MODEL: SR3/SR1 K8 ENGINE

**GEAR POSITION SENSOR WIRING ROUTING****PRIORITY – MEDIUM (MONITOR)**

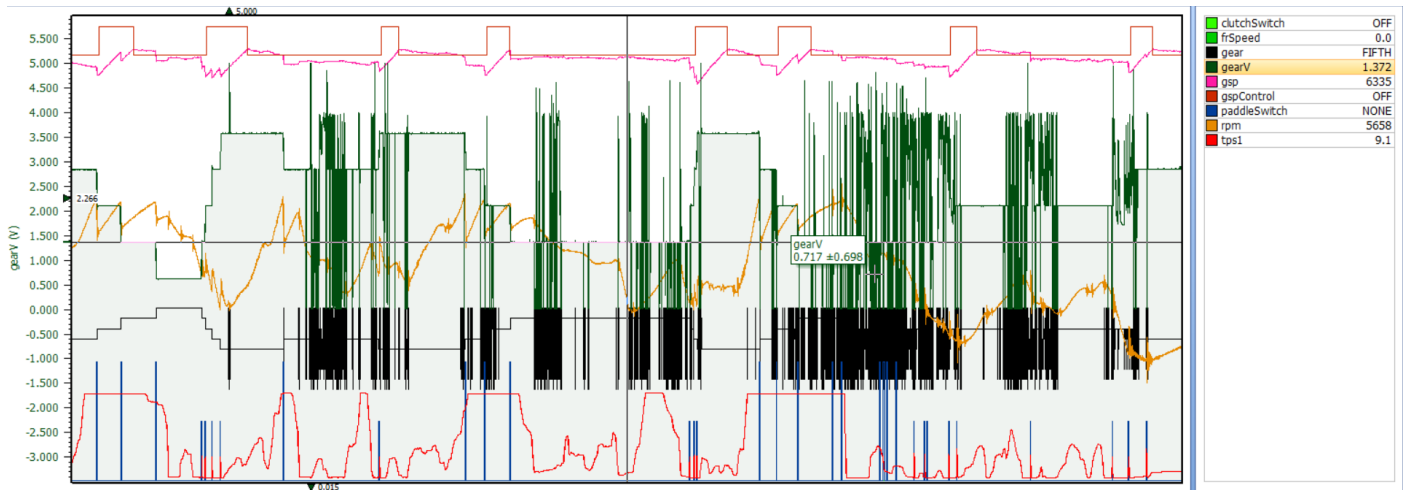
1. Driver will notice gear changes on display while gear change was not requested or shift issues when trying to change gear
2. Gear position and gear voltage trace on Life View will read incorreccted as shown below.

3. Physical inspection of the wiring will uncover heat damage or wiring damage as per the image below. Note that the wiring damage could be internal and not always as obvious.

1. Unplug the sensor and remove the heat sleeve.
2. Check the wiring and plug for any damage.
3. Release the whole length of the Gear position sensor wiring on the harness side.
4. Reapply the heat sleeve making sure the whole length of the wiring is covered. In case the heat sleeve is too short, source a replacement of correct length.
5. Secure heat sleeve on the engine side with cable tie.

6. Route protected wiring as far away from the exhaust as possible and secure in position using cable ties as per image below.
